## AGENDA - LPP

<b>Meeting:</b>	Georges River Local Planning Panel (LPP)
<b>Date:</b>	Thursday, 19 March 2020
<b>Time:</b>	4.00pm
<b>Venue:</b>	Council Chambers, Civic Centre, Hurstville
<b>Panel Members:</b>	Paul Vergoits (Chairperson) Michael Leavey (Expert Panel Member) John Brockhoff (Expert Panel Member) Cameron Jones (Community Representative)

**REPORT TO GEORGES RIVER COUNCIL  
LPP MEETING OF THURSDAY, 19 MARCH 2020**

<b>LPP Report No</b>	<b>LPP012-20</b>	<b>Development Application No</b>	<b>DA2019/0433</b>
<b>Site Address &amp; Ward Locality</b>	57-59 Clarke Street Peakhurst Peakhurst Ward		
<b>Proposed Development</b>	Demolition, lot consolidation and construction of a multi dwelling housing development, swimming pool over a car park and use of the completed dwellings as group homes		
<b>Owners</b>	Mr A Haidar and Mr L and Ms S Kaoutarani		
<b>Applicant</b>	Bruce Naghten		
<b>Planner/Architect</b>	Planner: Bruce Naghten, Architect: Bodesign		
<b>Date Of Lodgement</b>	23/09/2019		
<b>Submissions</b>	Twenty two (22) submissions received		
<b>Cost of Works</b>	\$2,605,751.68		
<b>Local Planning Panel Criteria</b>	More than ten (10) unique submissions objecting to the propo

**Figure 12:** Inset of extract of northern side elevation indicating maximum height of building (Source: BoDesign, 2019)

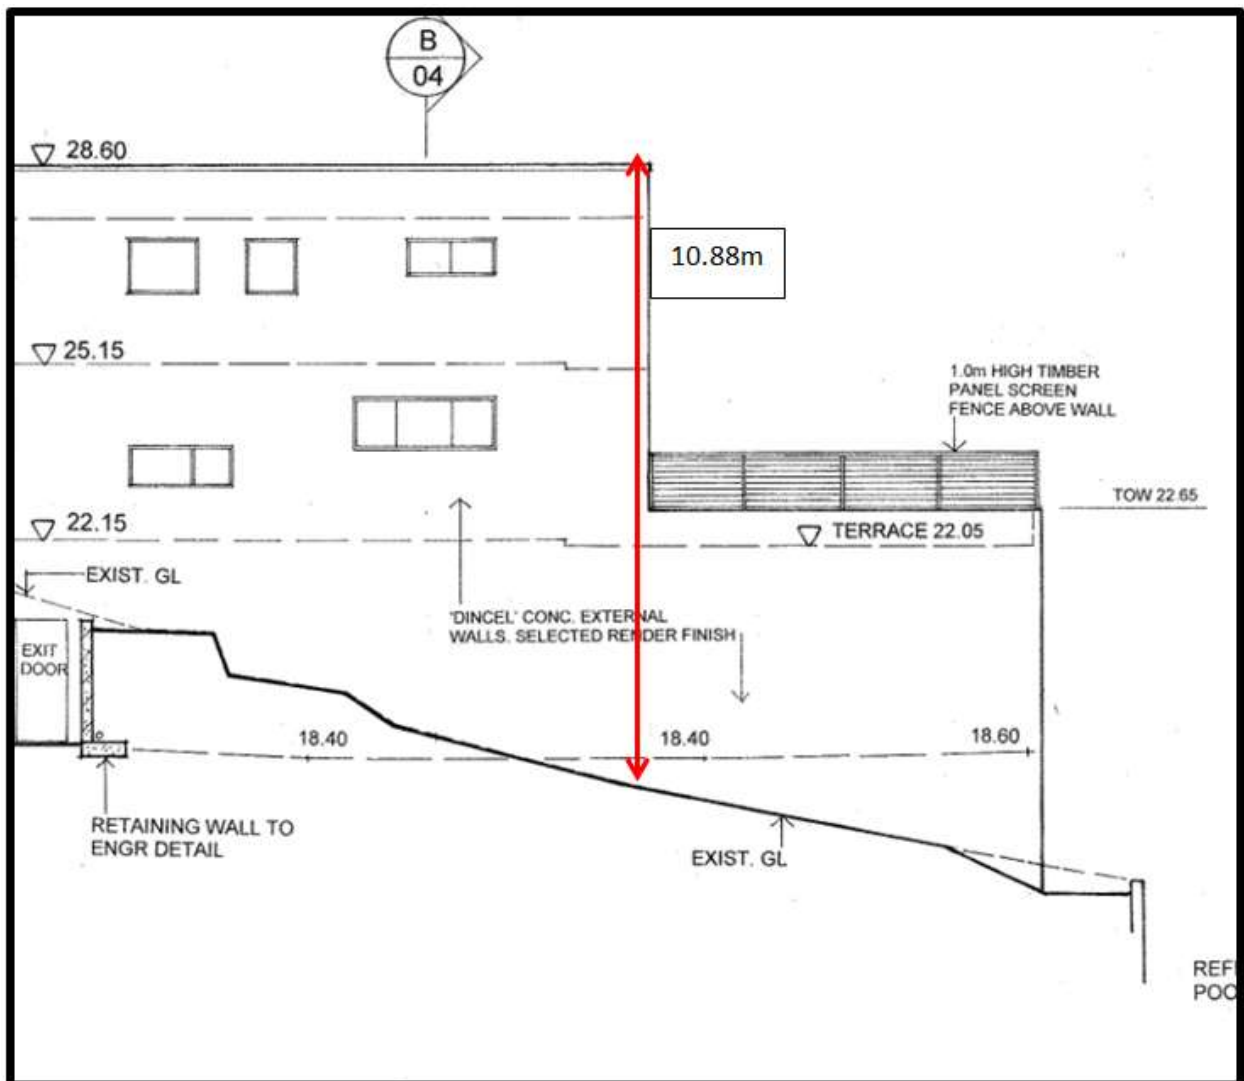
<p><b>4.3 Height of Buildings</b></p>	<p>9.0m</p>	<p>Range: 9m - 10.88m maximum height measured along the northern side elevation and roofed rear balcony of Unit 4 at the centre of the site.</p>	<p>No (2) - refer to discussion below.</p>
---------------------------------------	-------------	--	--

The proposal seeks an excessive built form with a maximum height of 10.88m which does not appropriately respond to the sloping topography of the site. This results in adverse visual bulk and unnecessary solar access impacts on adjoining southern properties.

Figure 13: Extract of southern side elevation of Units 2 - 3 (Source: BoDesign, 18)

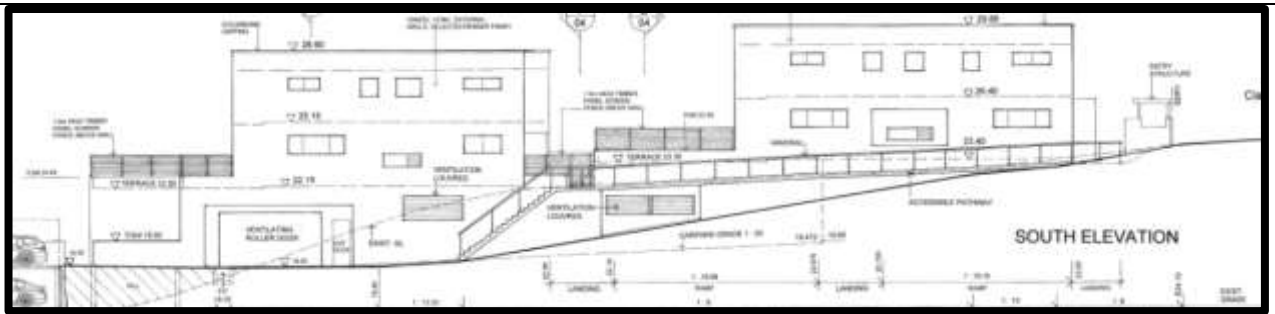
The proposal seeks a three storey element for Units 3-4 at the centre of the site which is not considered appropriate and results in adverse visual bulk and scale and unnecessary overshadowing impacts to the adjoining properties to the south.

Figure 14: Extract of northern elevation of Unit 5 (Source: BoDesign, 18).

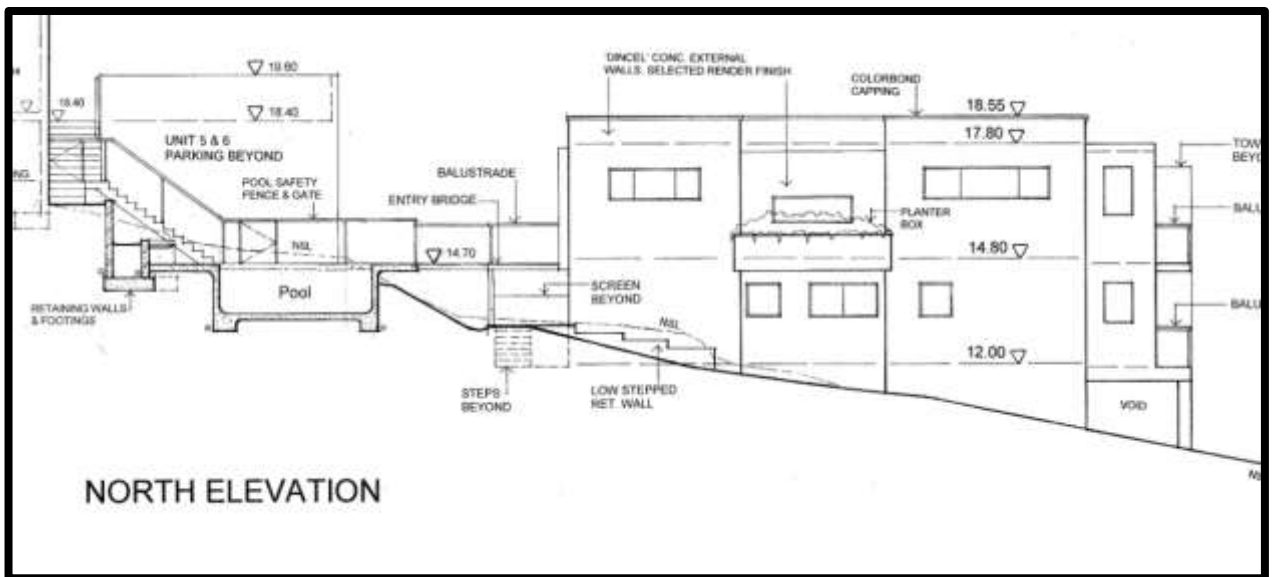
The proposal seeks a two storey built form at the rear of the site, which is not compatible with the surrounding area and results in substantial visual bulk adjacent to rear yards in a low density area. It is noted that the applicant has been advised in the form of a rejection letter to a previous application that a single storey built form would be required. The proposal results in unnecessary visual impacts and additional overshadowing impacts to adjoining properties to the south.

**Figure 15:** Extract of site Plan showing the location of Units 1-6 (Source: BoDesign, 18)

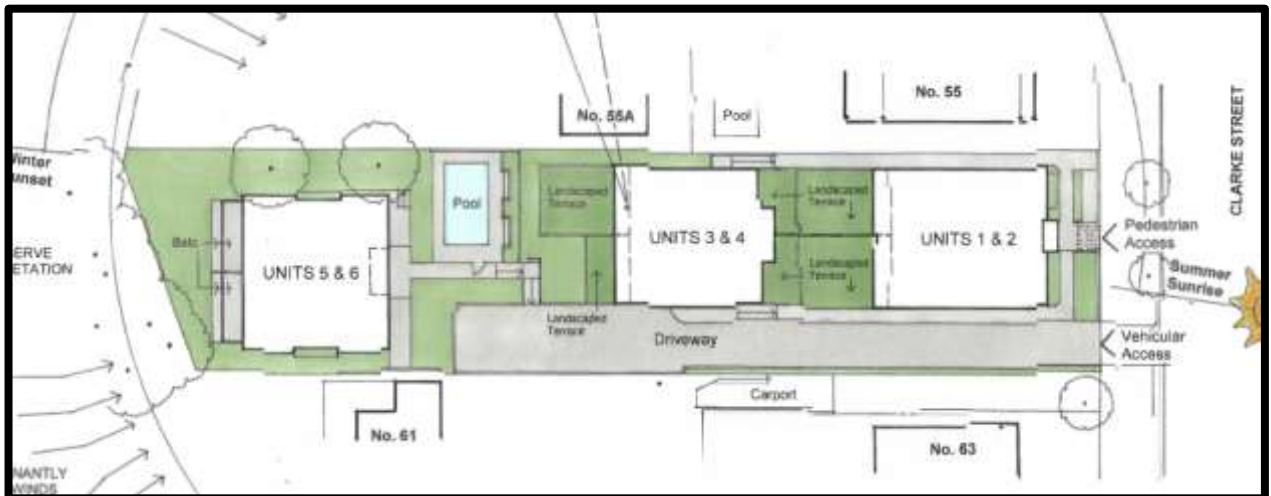
The proposal seeks variations to the side setbacks at numerous points along the elevation. This is considered to be due to a poor layout which is not responsive to the site and context. It is noted that the applicant had been advised on two (2) occasions that side setbacks less than 3m would not be supported by Council Officers through the pre-lodgement process and previously rejected application.

**Figure 16:** Extract of rear site plan of Units 5-6 (Source: Bo Design, 18) (Note - diagram reorientated to be consistent with site plan)

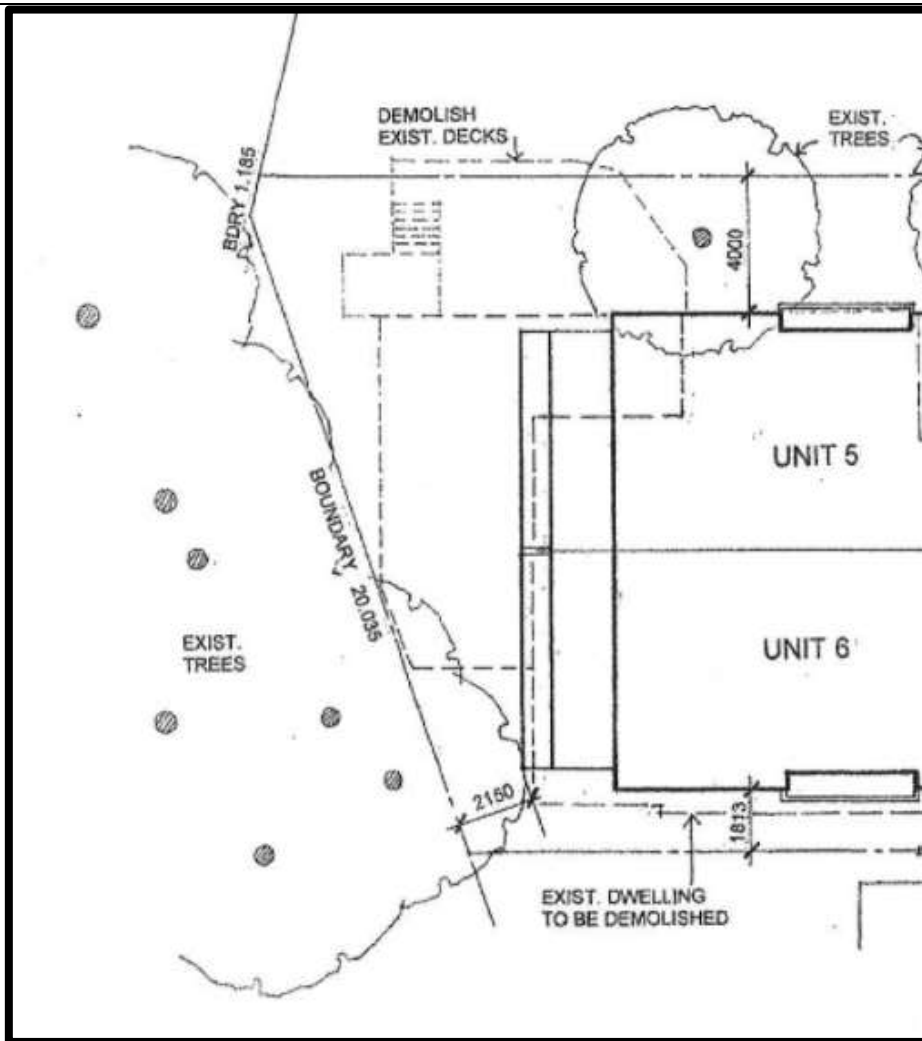
The proposal provides an insufficient rear setback of less than 6m. This also results in inadequate private open space for Unit 6 and unnecessary overshadowing impacts to the adjoining southern properties.

**Figure 17:** Inset of basement car park which is located above natural ground level along the southern side elevation (Source: Bo Design, 18)

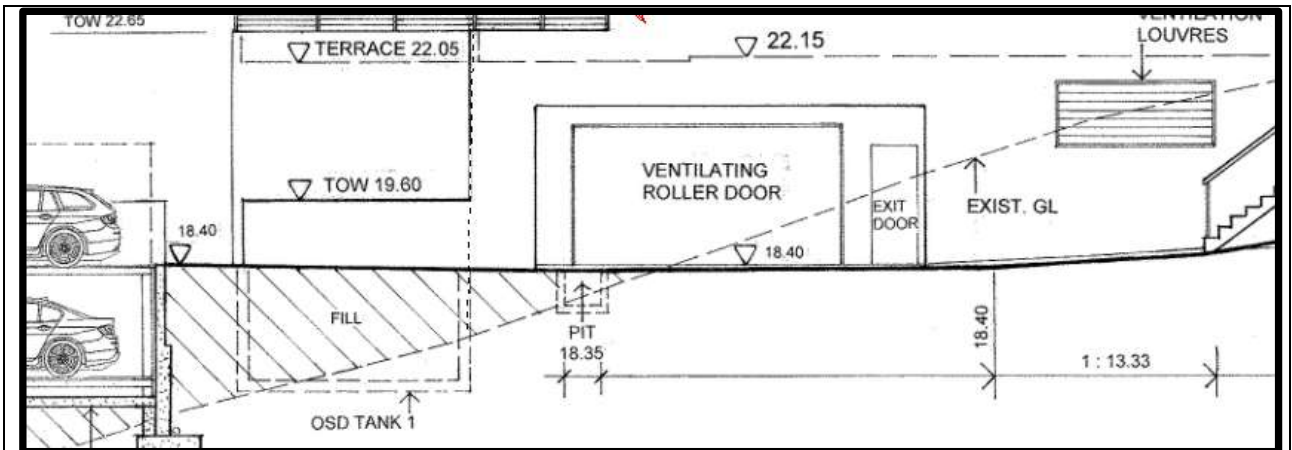
As per the above extract, the proposal results in significant unnecessary visual bulk which seeks a significant departure from Council’s controls (at its rearmost point, the basement projects 5.3m above natural ground level).

**Figure 18:** Inset of proposed front setback (Source: Bo Design, 18) (Note - diagram reorientated to be consistent with site plan)

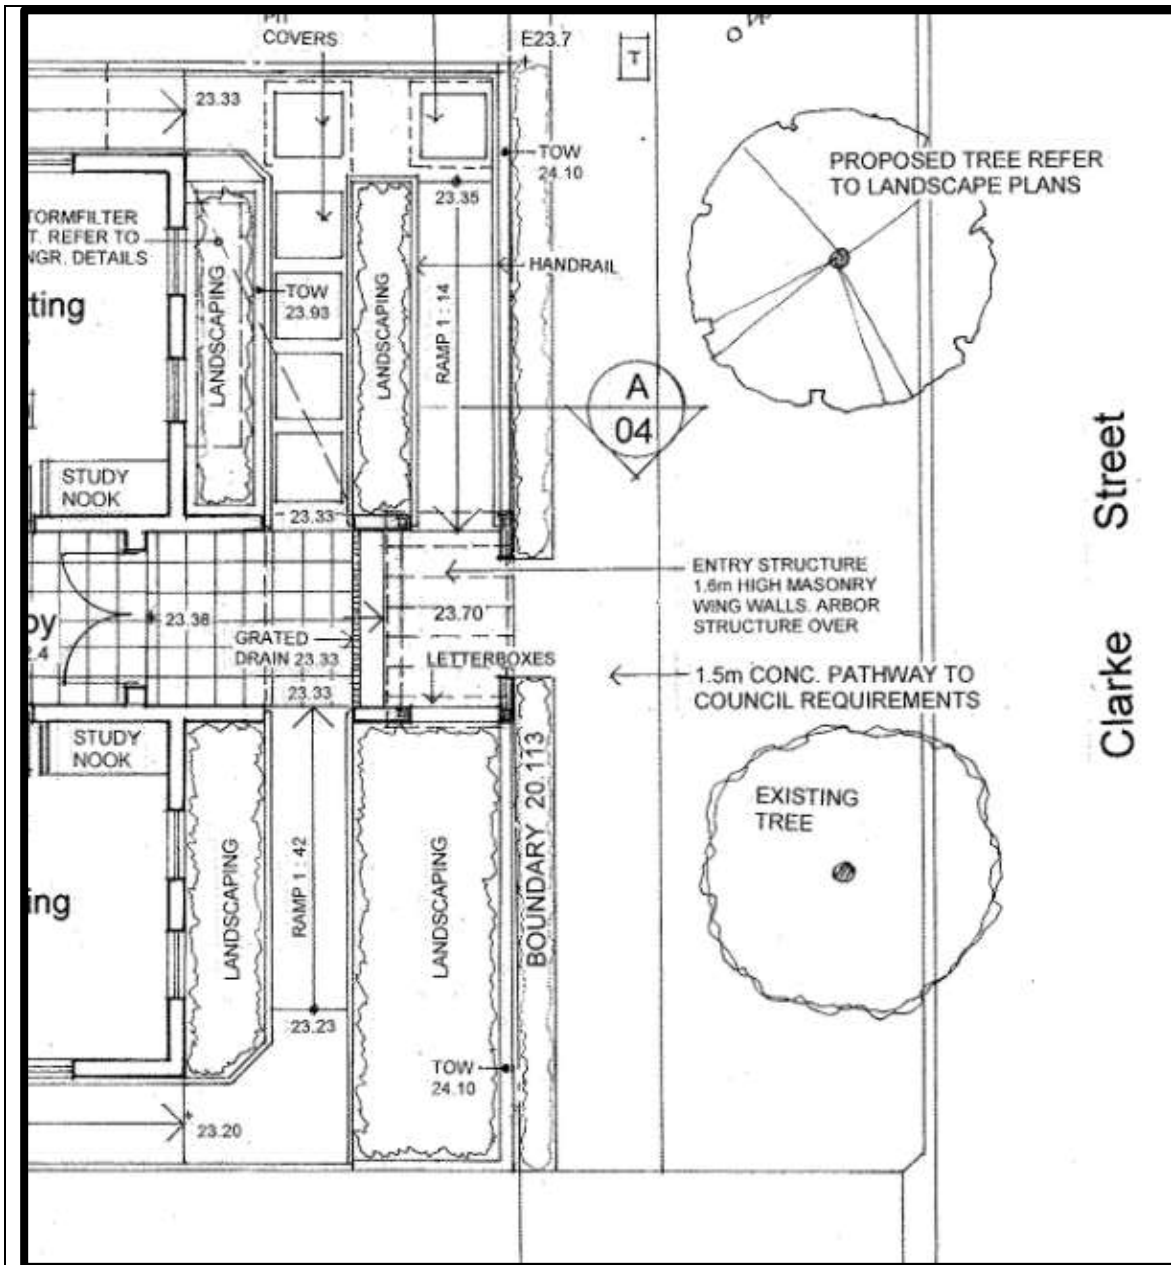
The proposal seeks excessive ramping to provide access. This is considered to result in an unnecessary design which provides multiple separate pathways to separate units due to an unresolved design.

Figure 6 – Site plan showing T1 to be retained and location of ground floor

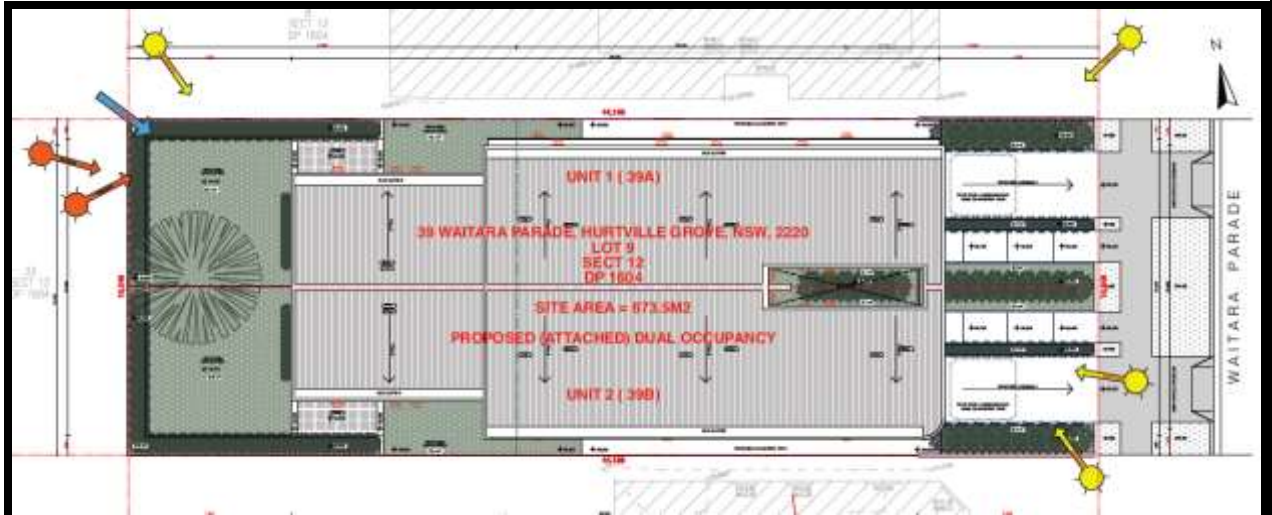
encroaches the structural root zone of the tree by 18% which cannot be supported.

49. The amended design of the proposed dual occupancy proposes the retention of one Oak tree (T1) and removal of one Oak tree (T2) see Figure 6. In order to retain the tree (T1) the consulting arborist has recommended a gap in the dividing fence that separates the private open spaces of each proposed dwelling.
50. Council's Consulting Arborist has undertaken an assessment of the proposal and cannot support the proposal as the ground floor will encroach into the structural root zone of the Oak tree by 18%, compromising its health and survival. The design submitted with this Review application does not adequately address the reason for refusal of the DA in relation to tree impacts, and this forms one of the reasons for refusal.

Figure 4: Approved basement car parking level and the layout

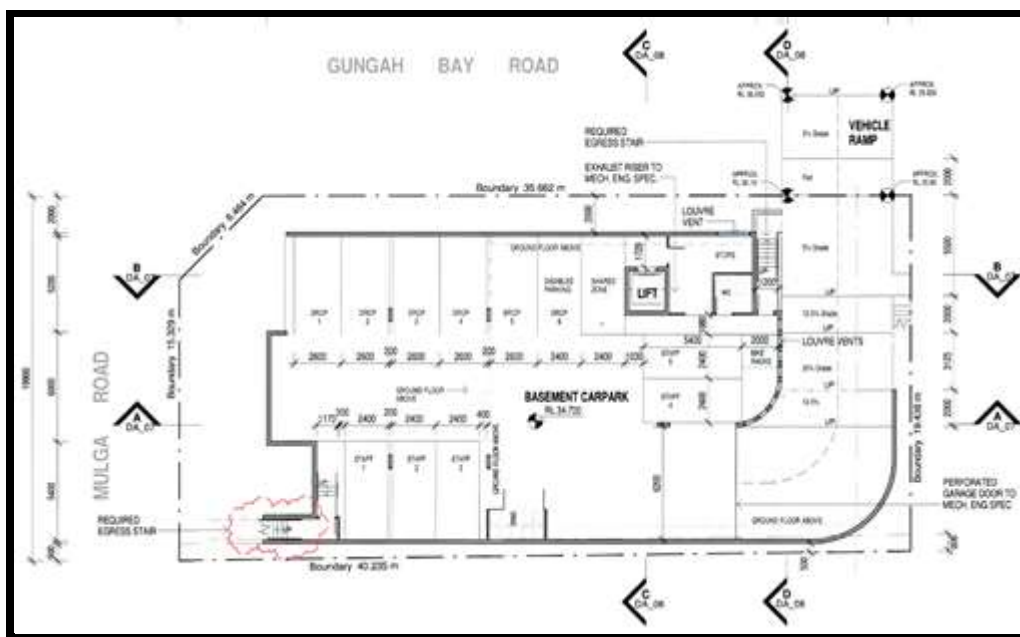
60. The approved number of children remains unchanged which is 49 and this generates a need for 5 off street car parking spaces. The originally approved number of staff was 11 which generated a need for 6 spaces (rounded up). The total number of car parking spaces required was eleven (11). This was catered for in the basement car parking level of the approved scheme as shown in the diagram below (Figure 4). The additional 3 staff members will create the need for an additional car parking space. The 13 staff members as proposed by this application generates the need for seven (7) off street car parking spaces.

61. The basement car park shows 6 drop off spaces and 5 staff spaces however condition 58 rectifies the actual dedication of parking and states;
